Corsair Memory, Inc.

Declaration of Product Modifications

This is to request a Class II permissive change for FCC ID: 2AAFMRDA0047 originally granted on 03/17/2023.

MAIN_L PCB hole position design adjustment. It can't see the change from the outside:

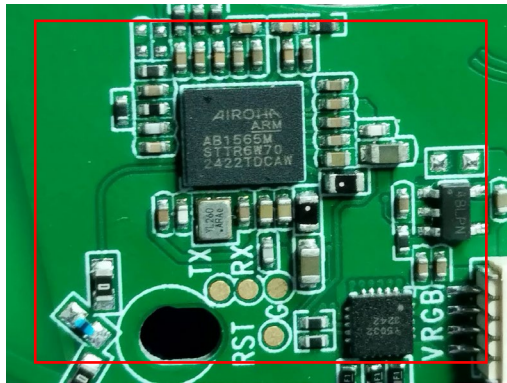
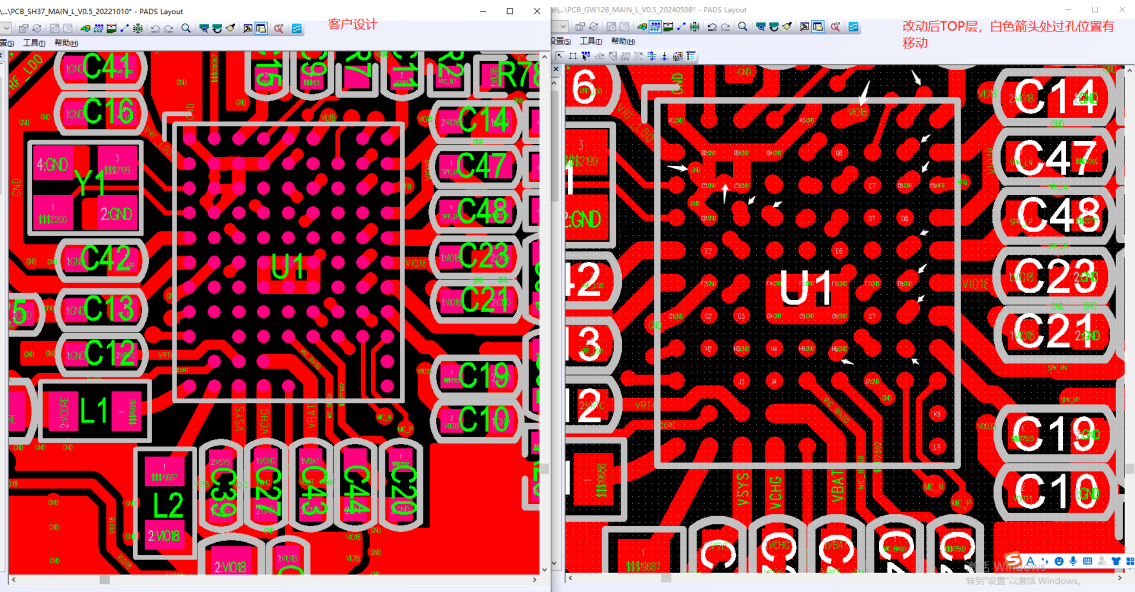
Change #1: After the change, the position of the hole at the white arrow has moved to the direction of the pad at most 0.1mm Minor pore changes on the TOP Layer

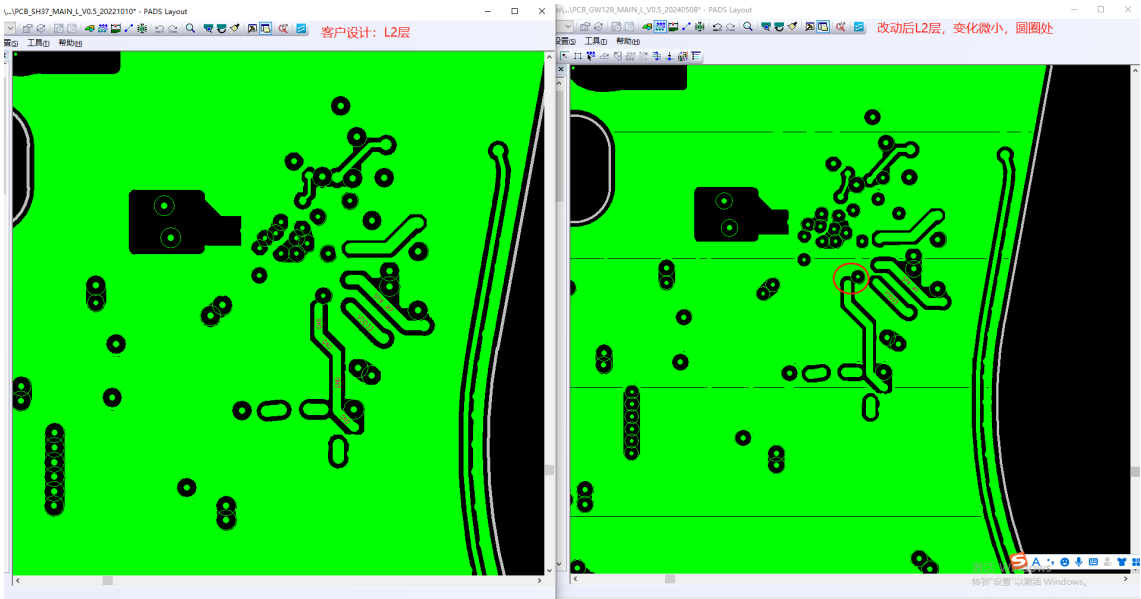
Change #2: Minor pore changes on the Layer 2

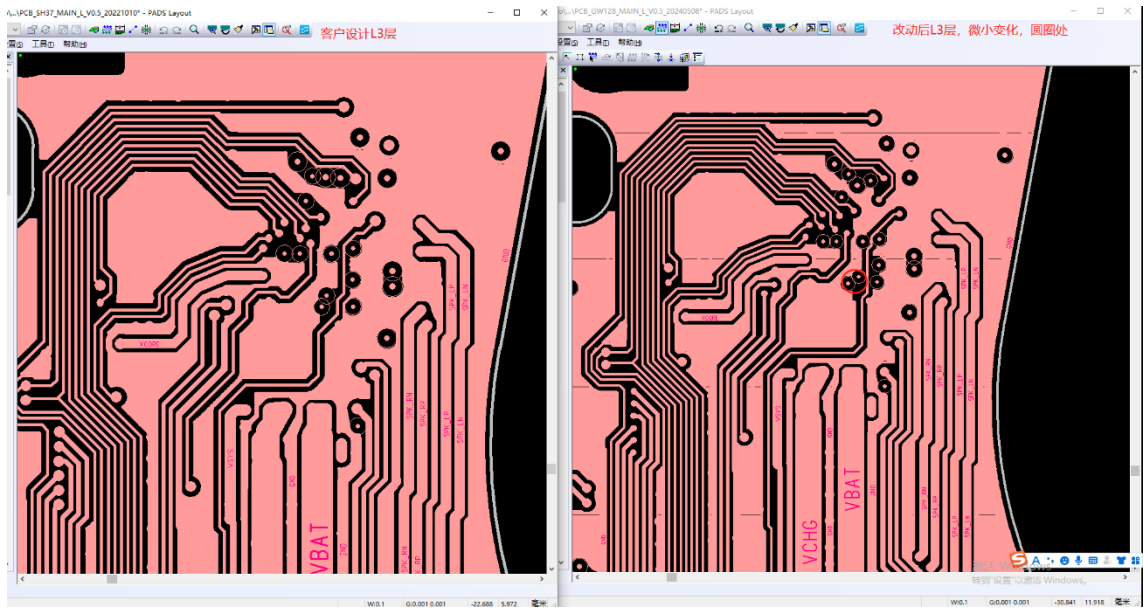
Change #3: Minor pore changes on the Layer 3

Change #4: Minor pore changes on the Layer 4

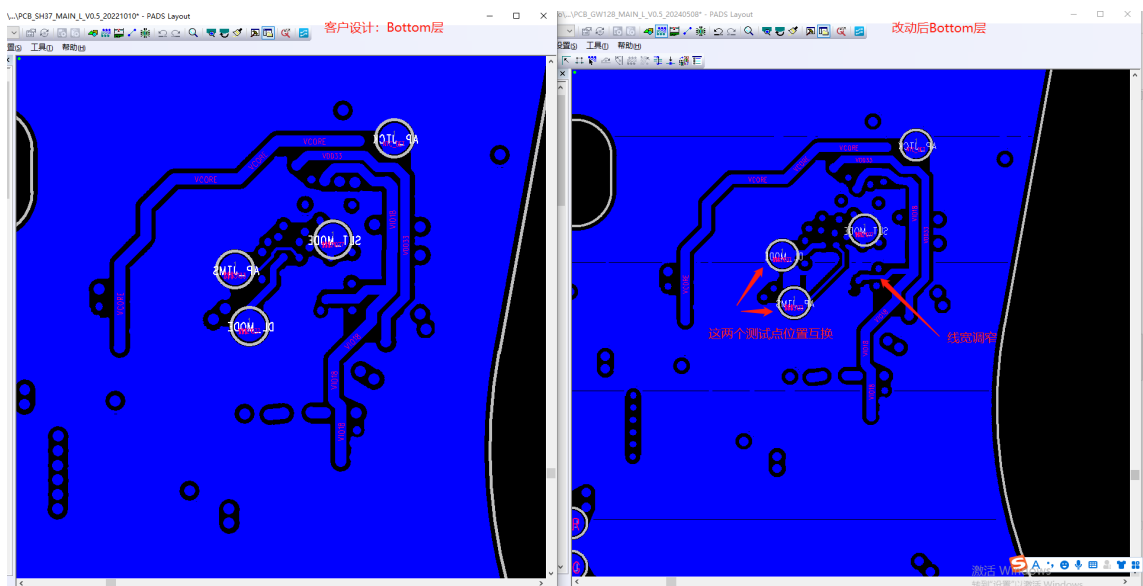
The positions of the two test points are exchanged. After the change, the narrowest line of VIO18 in the middle of the two holes is 0.15mm
